**The Sizewell C Project, Ref. EN010012**

## **Suffolk County Council comments on responses to ExA's Written Questions (ExQ1)**

**Deadline 3**

**24 June 2021**

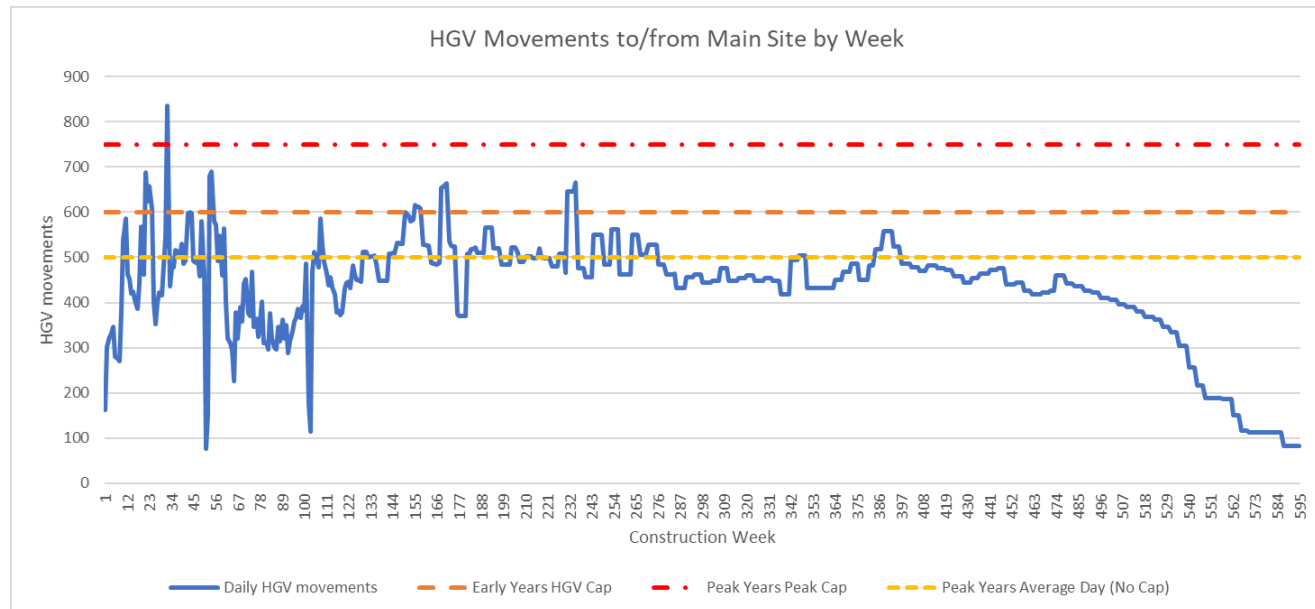
Year	Maximum	Minimum	Mean	1	836	76	461	2	690	114	375	3	600	372	485	4	664	370	<b>520</b>	5	666	456	<b>515</b>	6	550	432	475	7	504	418	450	8	558	450	488	9	476	418	453	10	460	380	418	11	368	116	252
Year	Maximum	Minimum	Mean																																														
1	836	76	461																																														
2	690	114	375																																														
3	600	372	485																																														
4	664	370	<b>520</b>																																														
5	666	456	<b>515</b>																																														
6	550	432	475																																														
7	504	418	450																																														
8	558	450	488																																														
9	476	418	453																																														
10	460	380	418																																														
11	368	116	252

These would indicate that the ‘typical day’ would be consistently breached for both Year 4 and Year 5.

- The typical day may be being weighted by the last few years of the project which sees a tailing-off of the required number of HGV movements.
